12B Spent Fuel Pool Geometry and Dose Rate Calculation

Figure 12B-1 ~~SFP Layout and Dimensions~~ Spent Fuel Pool Analytical Model

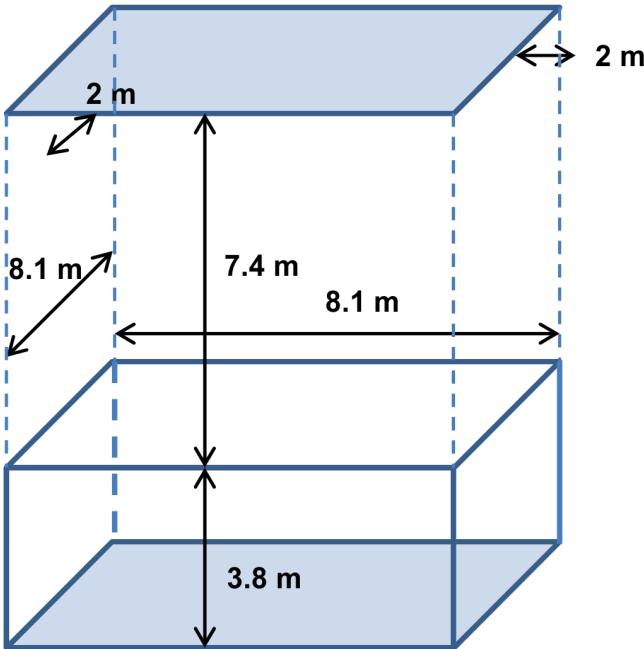
~~The SFP geometry is provided in FSAR Section 12.2, Tables 12.2-5a and 12.2-5b; and FSAR Section 12.3, Figures 12.3-6 and 12.3-10. The SFP storage rack has the capacity for 2365 BWR fuel assemblies. The size and configuration of the storage rack are given in Figure 12B-1, which shows an irregular rectangular cross section area extended to 10.7 m x 9.0 m. The fuel storage rack is situated at the lowest level of the SFP, where the total height of water is 11.6 m.~~

11.2 m – 3.8 m = 7.4 m (see Table 12.2-5c). There are 2 m thick concrete walls and floor surrounding the SFP on all sides. The floor of the SFP is 2 meters thick as well (see Table 12.2-5c). The water shielding and distance between the spent fuel racks and the surrounding walls in the pool are not considered. (See Figure 12B-1).

The SFP radiation source is used for the shielding design and analysis to ensure radiation levels at neighboring areas surrounding the SFP meet the design criteria. A simplified model of a rectangular parallelepiped of (8.1 m x 8.1 m x 11.2 m) is assumed to represent the SFP. The SFP peak radiation source is assumed to be homogenized over the bottom 3.8 m of the SFP to represent the active fuel length of a typical BWR fuel assembly. 3.8 meters was assumed to represent the height of the active fuel region, since this height results in the minimum required shielding of water,
